14 February 2025

ADDENDUM NO. 3

RE: Chisholm Creek Utility Authority  
Wastewater Treatment Facility Improvements  
WCI File: 20-600-514-00

SHEET NO:  
**E-710**

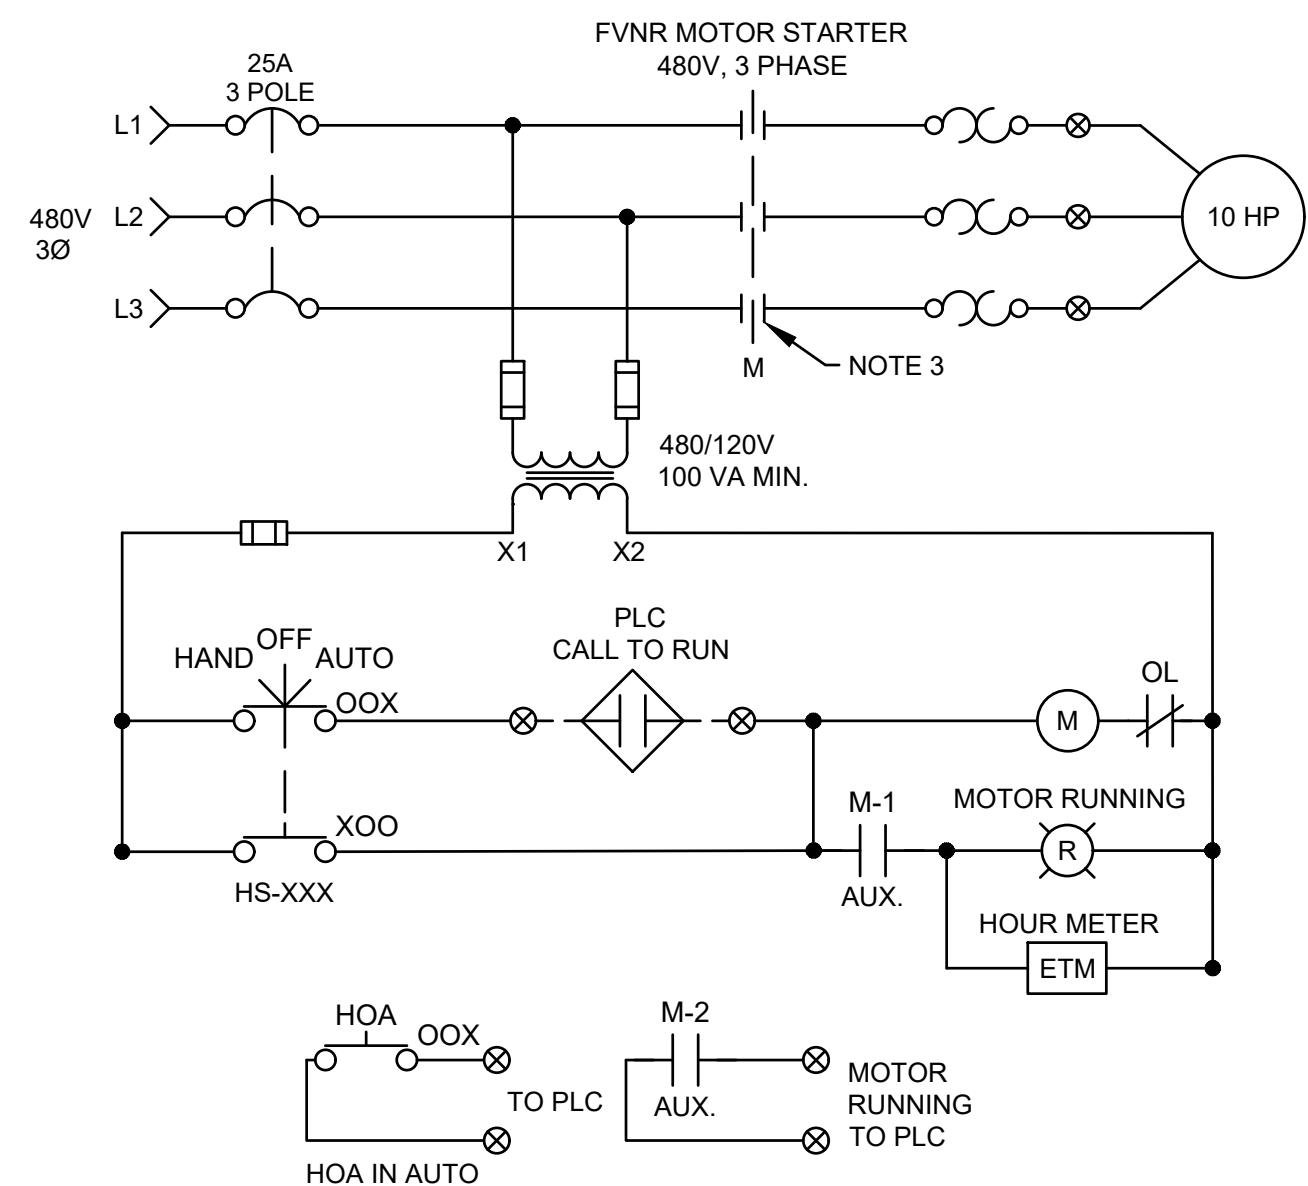
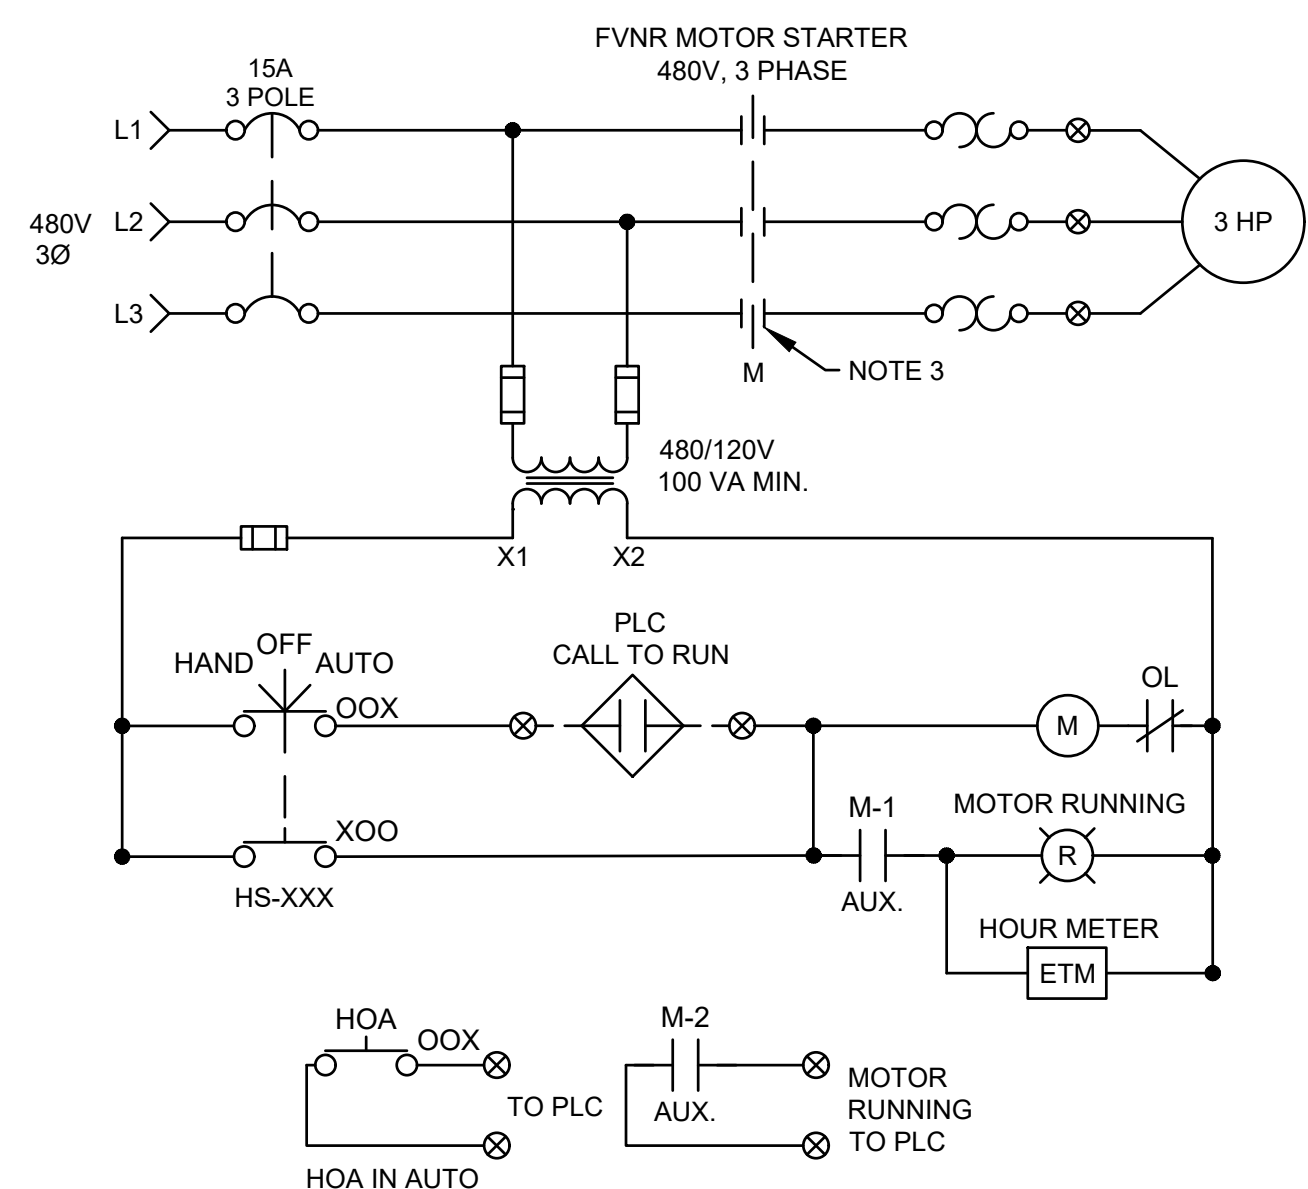
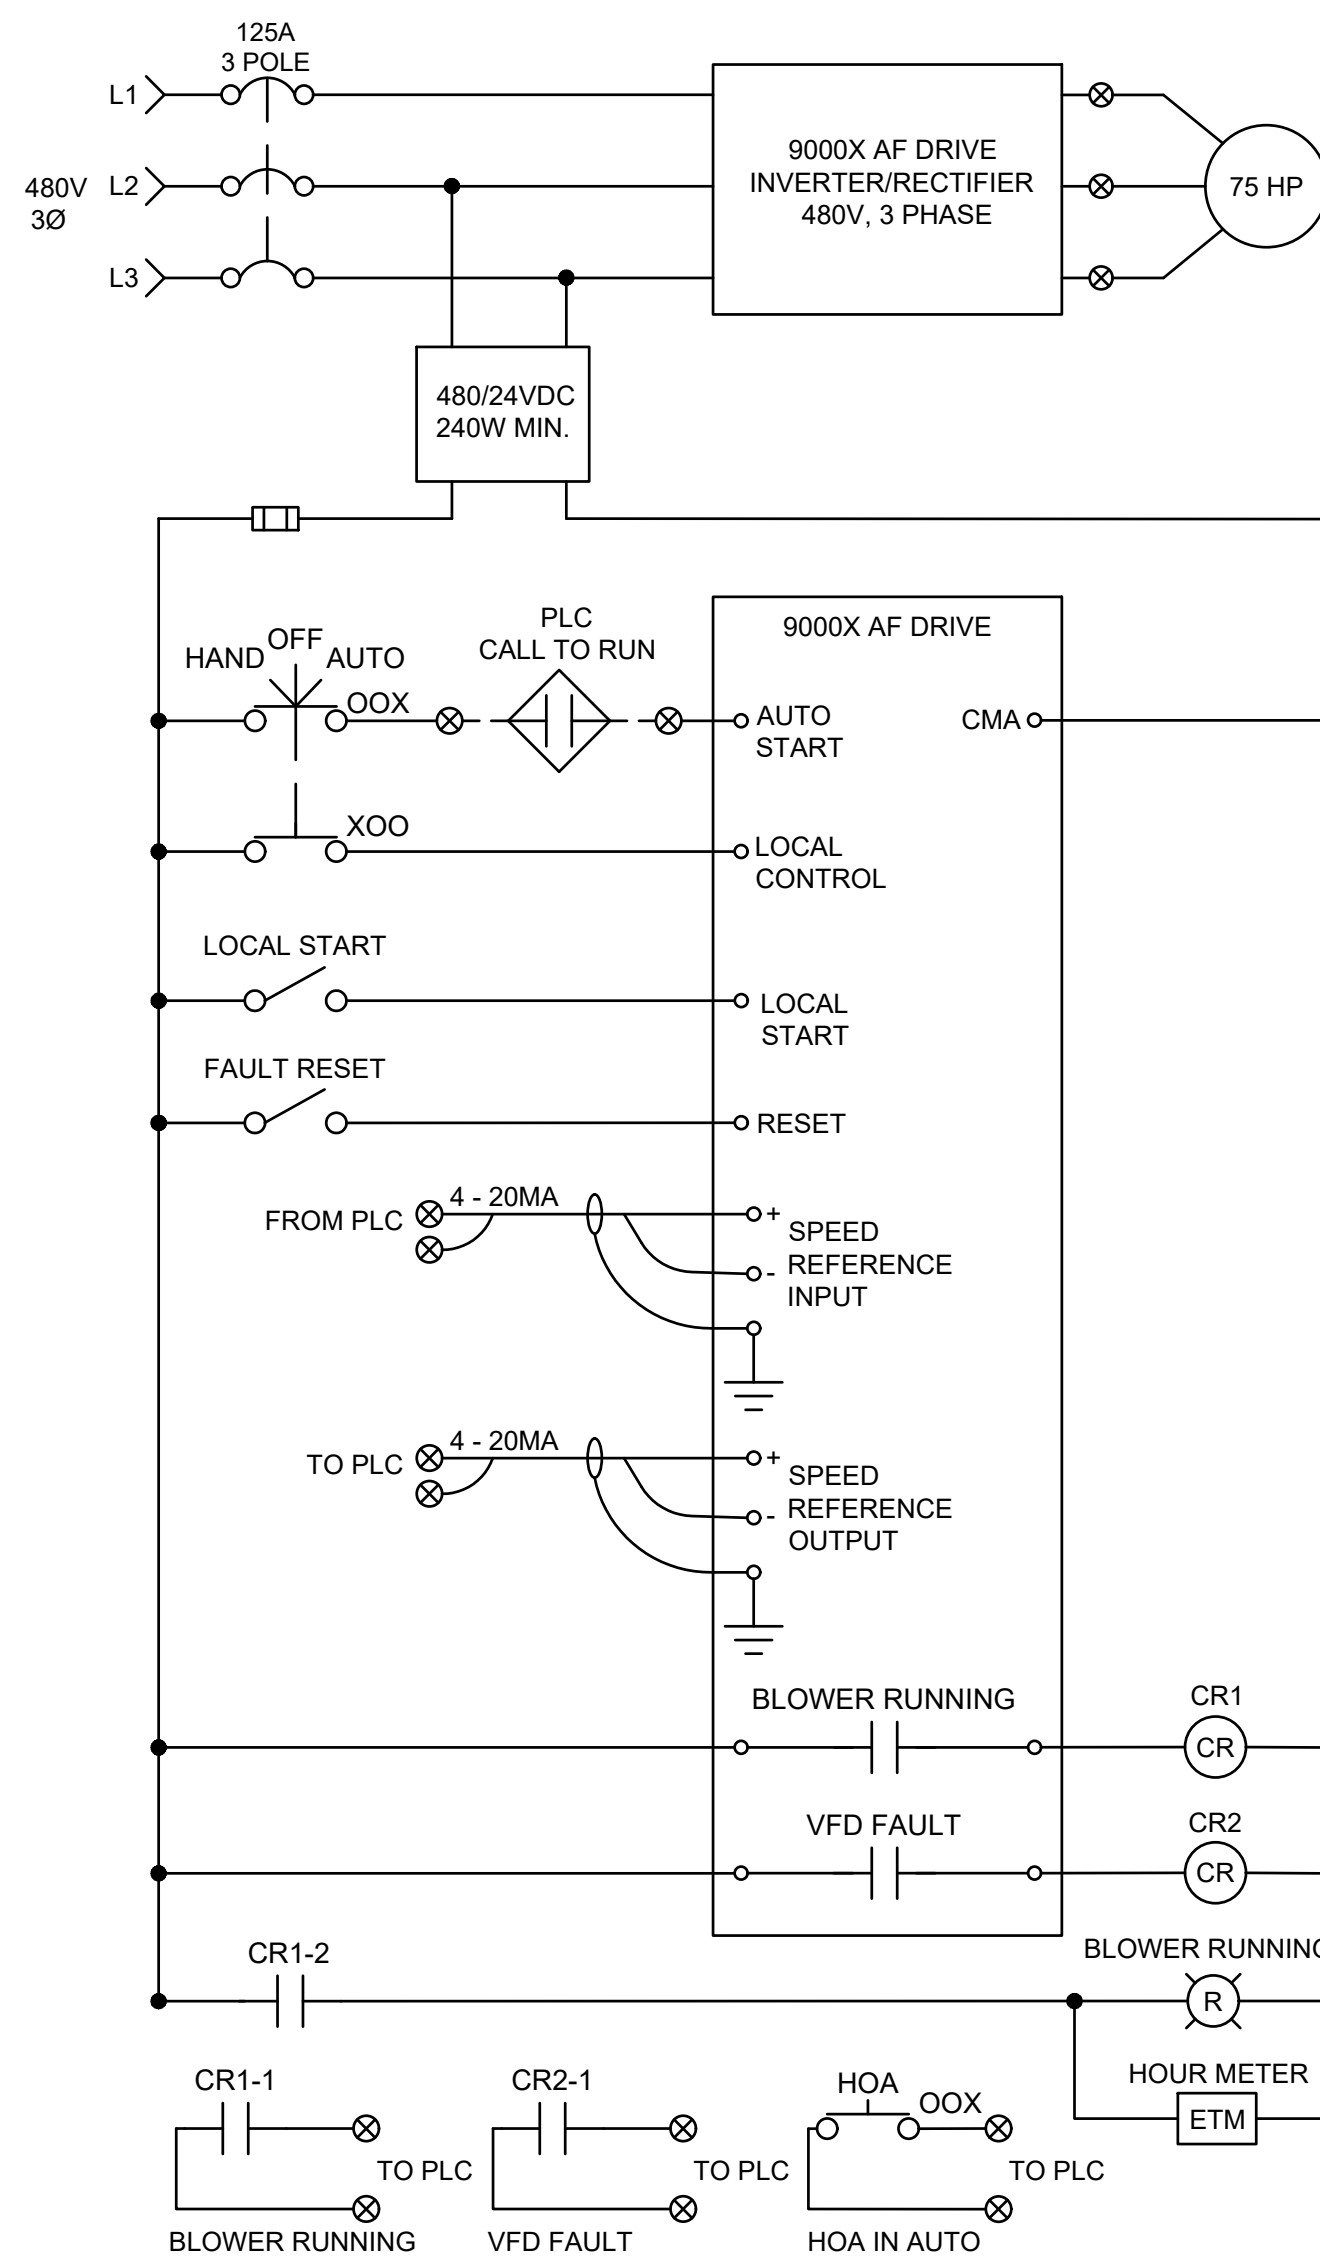
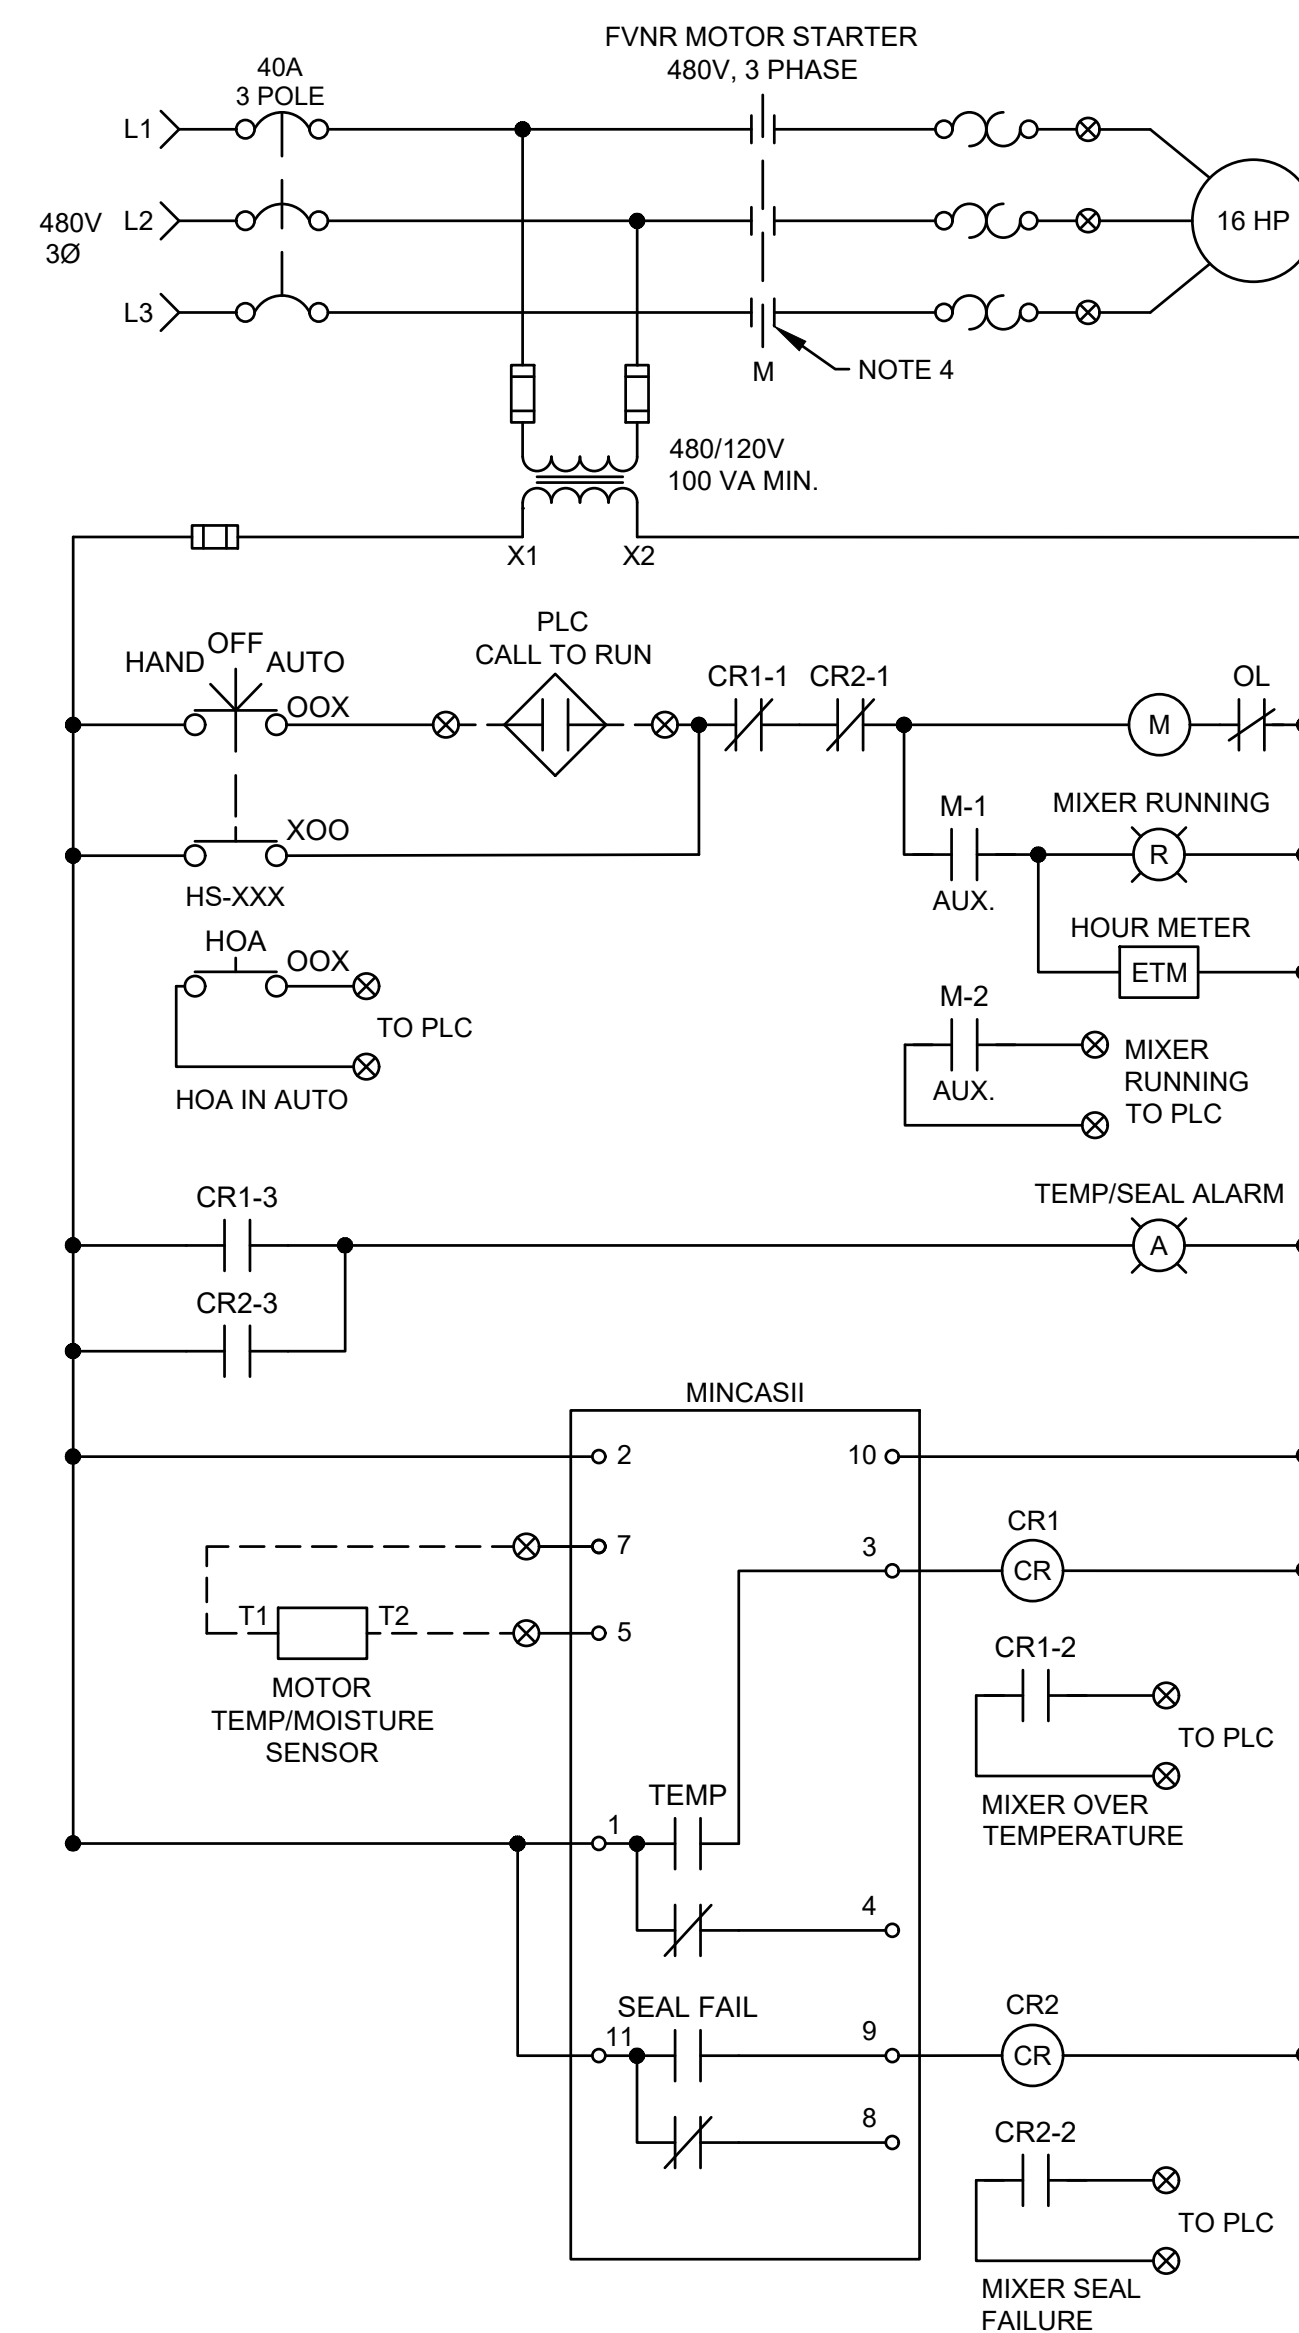
23. Sheet No. E-710  
ADDITION of sludge pump control diagram detail.
